Updates to DWG Procedure Manual based on feedback from IBRWG stakeholders

IBRWG/DWG Joint Workshop
August 9, 2024

Summary – Minor DWG Manual Updates since July 12

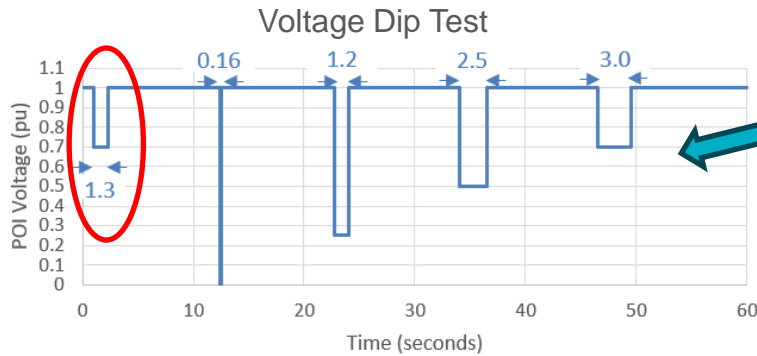
This dip is entirely within the Legacy VRT curve; thus, it is reasonable to expect legacy units to ride through the first dip.

Updated Plots and Language

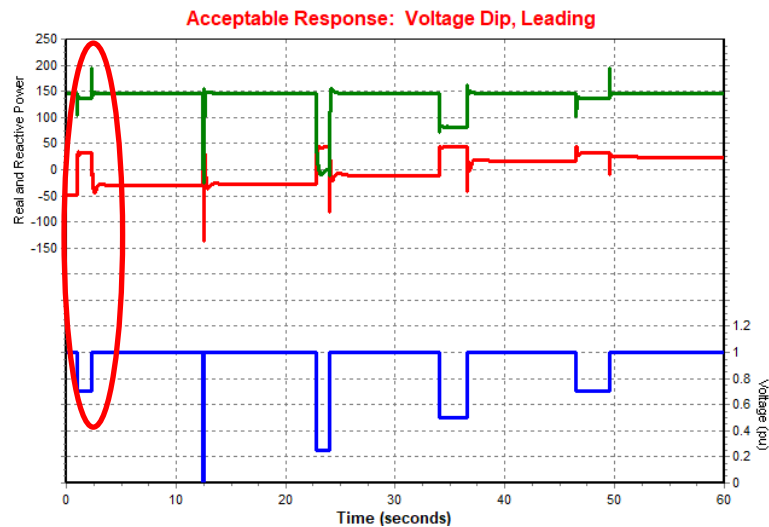
- Refer to supplemental presentation:
 - Added an additional voltage dip of 0.7 pu and renamed the plots from “Preferred Test” to “Voltage Dip Test” to indicate that the same profiles should be used for both new and legacy Resources.
 - Example in DWG Procedure Manual is also updated.
 - Clarified DWG language criteria to match NOGRR-245 update to NOG 2.9.1.1.

When testing the “voltage dip” while, the following criteria applies:

- Resources not subject to the “preferred” Voltage Ride Through requirements of NOG 2.9.1.1 are only required to ride through the first dip of the below voltage dip profiles. This first dip is within the “legacy” LVRT requirements of NOG 2.9.1.2

- During the voltage dips:
 - The model shall inject active current for POI voltage dips of 0.5 and higher.
 - Injections of significantly reduced active current for voltage dips 0.5 pu and 0.7 pu should be accompanied by increased reactive current.

- Reactive current injection at the POI shall be observable immediately or very shortly after a non-zero voltage dip is applied.
- After the voltage dips:

- Real power should recover to full output within 1.0 seconds of POI voltage recovery to 1.0 pu.
- An explanation, including a reference to any exempt status per ERCOT Nodal Operating Guide Section 2.9.1, shall be provided for models which indicate that the unit trips or fails to meet any of the above performance criteria.
